PROPOSED AMENDMENTS (notes in red)

Table with project information: Job Title (THE REDDINGS, Frertherne, Stable Conversion), Drawing Title (Proposed Plans & Elevations), Drawn (HD), Checked, Date (20.10.2020), Scale (1:100 @ A1), Job Number (1657.20), Work Stage (NMA APP), Drawing Number (AL.P.100), and a revision column.

PROPOSED BAT MITIGATION DORMER TYPE ROOF ACCESS

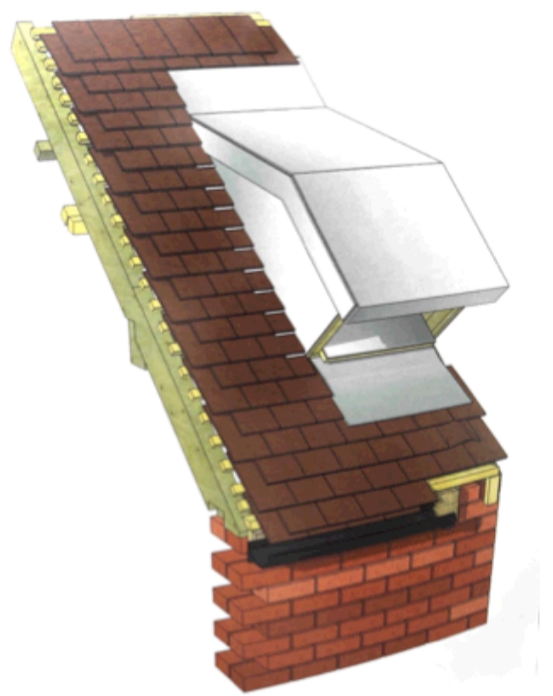
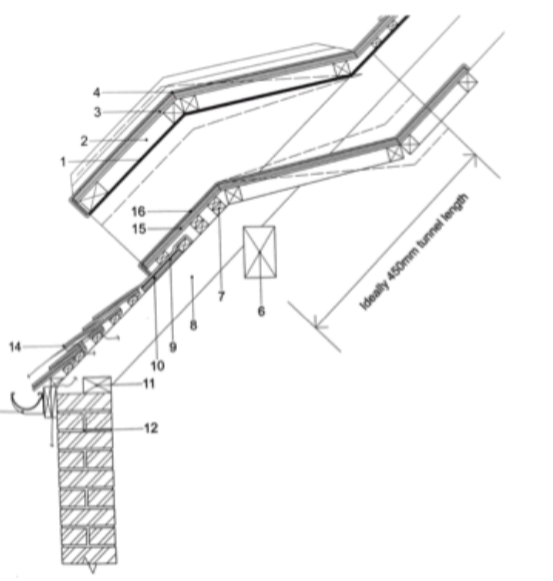
see CE Report for details & specification
